ADDITION TO SEDGWICK COUNTY, KANSAS

Re: S/D 97-66 One-Step Final Plat of SCHMIDT-SHEAHAN ADDITION

S/D 97-66 -- One-Step Final Plat SCHMIDT-SHEAHAN ADDITION

CASE NUMBER: S/D 97-66 SCHMIDT-SHEAHAN ADDITION

SCHMIDT-SHEAHAN

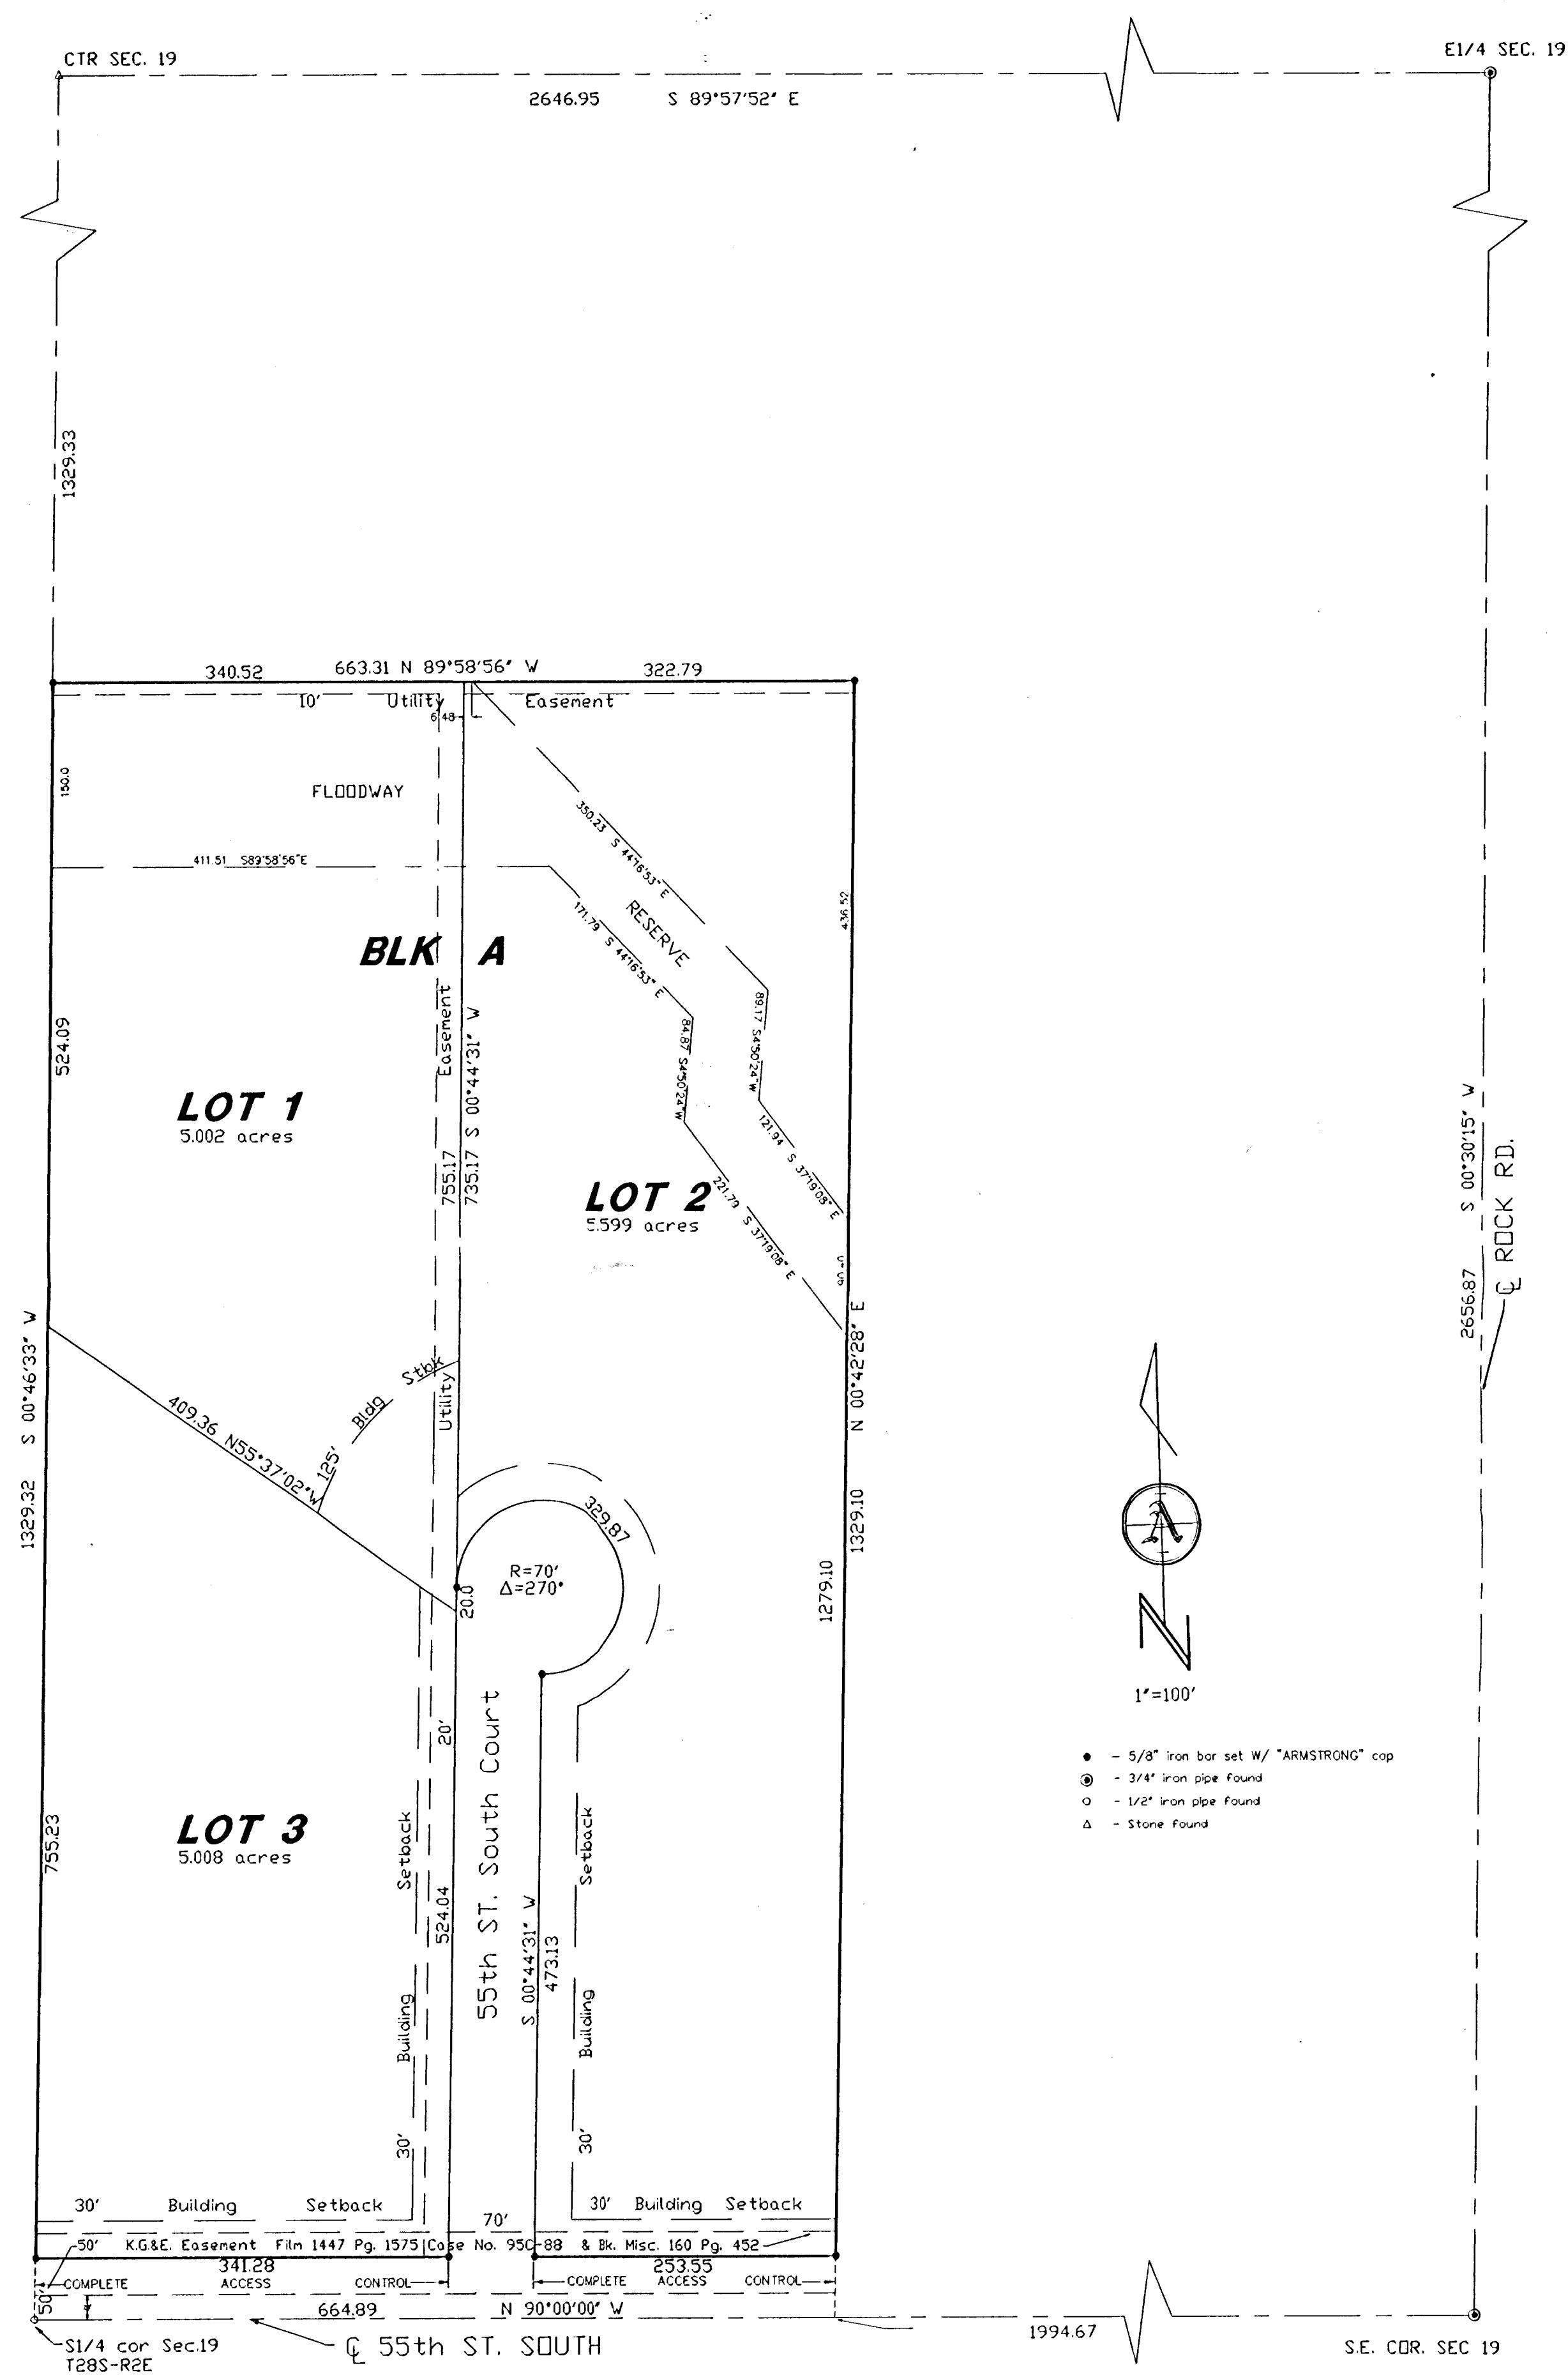
- D. County Engineering should comment on the status of the applicant's drainage plan. *The final plat tracing shall reference a minimum building pad elevation of 1350 MSL for Lots 1 and 2.*

- E. The applicant shall guarantee any drainage improvements required by the platting of this property.
- F. *The right-of-way width and street surface should be approved by County Engineering. A 36-foot wide suburban, gravel street standard is required.*

- H. For any lots with existing tree rows (western line of Lots 1 and 3) that may be impacted by the installation of utilities, it is recommended that overlywide utility easements (30 foot) be platted in order to allow for the installation of the utilities without damage to such tree rows.

- I. The platlor's text should be amended to read, "... Lots and a Block ...", instead of being singular as it is now. Also the footage from the tie point to the western most point of the plat (1994.67) should either read 2659.56, or the 1994.67 should be shown as the footage from the tie point to the eastern most point of the plat along 55th St. South.

- J. The applicant is advised that the final plat has indicated the platting of a 35-foot front yard building setback which exceeds the 30-foot zoning requirement. The 35-foot setback would therefore apply if platted as shown. **The applicant indicated a 30-foot setback would be provided on Lots 2 and 3.**

- K. The building setback line for Lot 1 must be relocated to meet the zoning requirement of a 200-foot lot width.
- L. The applicant shall install or guarantee the installation of all utilities and facilities which are applicable and described in Article 8 of the MAPC Subdivision Regulations. (Water service and fire hydrants required by Article 8 for fire protection shall be as per the direction and approval of the Chief of the Fire Department.)

- T. The final plat shall correct the MAPC signature block to reference Richard Lopez as the MAPC Chairman.
- U. The final plat shall correct the Chairman Pro-Tem signature block to reference Paul W. Hancock and not Bill Hancock.

- W. The surveyor's certification of the plattor's text shall be amended to read "Sheahan" not "Sheahand".
- X. Indicated in the platting binder is a pipeline easement which is not denoted on the final plat. This easement should either be shown on the site or verification provided indicating that it has been released.

BB. A waiver of the lot width/lot depth 2.5-to-1 ratio is recommended to be waived if the applicant reconfigures the plat by combining the Reserve with Lot 2.
